Entergy Operations, Inc.  
1448 S.R. 333  
Russellville, AR 72802  
Tel 479-858-4704

2CAN051202

SUBJECT: Additional Information Related to Request for Alternative ANO2-ISI-007  
Code Case N-770-1 Baseline Examination  
Arkansas Nuclear One, Unit 2  
Docket No. 50-368  
License No. NPF-6

**Additional Information Related to  
Request for Alternative ANO2-ISI-007  
Code Case N-770-1 Baseline Examination**

**DM Weld # 08-014**

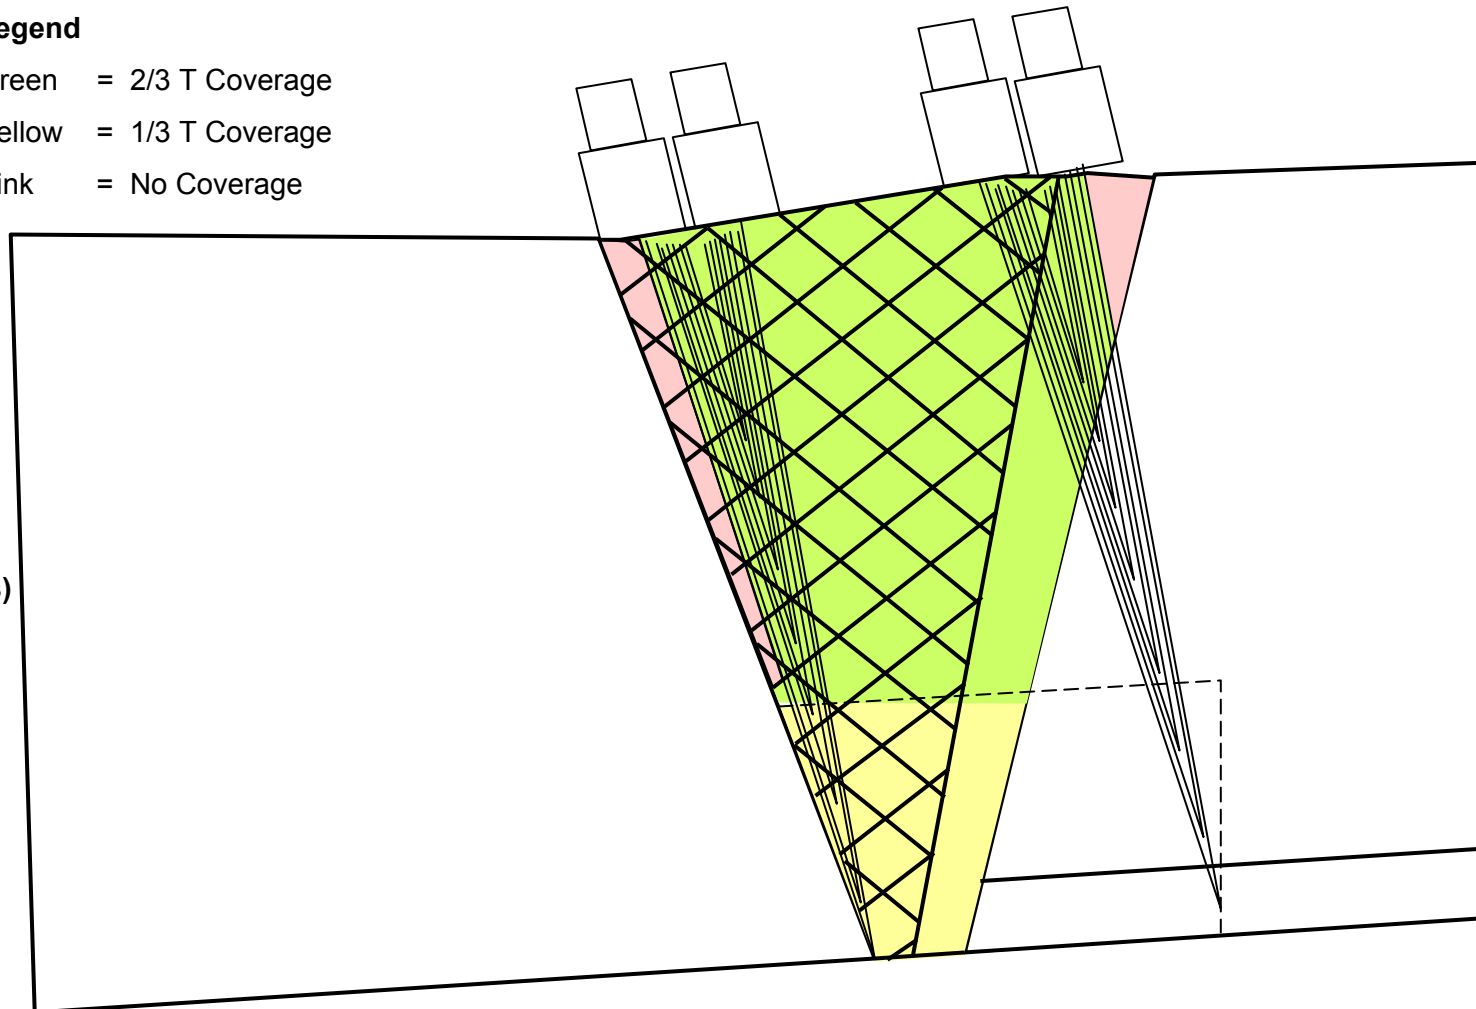
- 1. The response to Question 5 of the Request for Additional Information (RAI) response states that the coverage limitations are the result of irregular surfaces or tapered surfaces. The staff is concerned by the different coverage which would result from these geometries; intermittent lack of coverage due to irregular weld surfaces is significantly different than a continuous lack of coverage at the root which could result from a tapered weld surface. Please describe the reason for the lack of examination coverage for the susceptible material in each weld and, if due to weld taper, whether the root of the weld is being examined.**

<b>Component Number</b>	<b>Lower 1/3 Thickness (T) Circumferential Scan Coverage %</b>	<b>Upper 2/3 T Circumferential Scan Coverage %</b>	<b>Sketch Location of Circumferential Coverage Limitation of the Susceptible Material Volume</b>
08-014	100	92	Limitation in upper 2/3 T inconel weld at cast austenitic stainless steel (CASS) bevel preparation area and at cap transition to elbow.
09-008	55	64	Limitation to coverage appears to be concave area near center of weld cap indicating missed scan coverage is in the inconel weld, cap to root.
10-014	14	73	Limitation appears to be from weld taper and indicates the majority of the limitation is in the inconel weld and adjacent butter region with no coverage of weld root area.
11-008	62	73	Limitation to coverage appears to be convex area near center of weld cap indicating missed scan coverage is in the inconel weld, cap to root.
12-014	50	86	Limitation appears to be from weld taper and indicates the majority of the limitation is in the inconel weld with little coverage of weld root area.
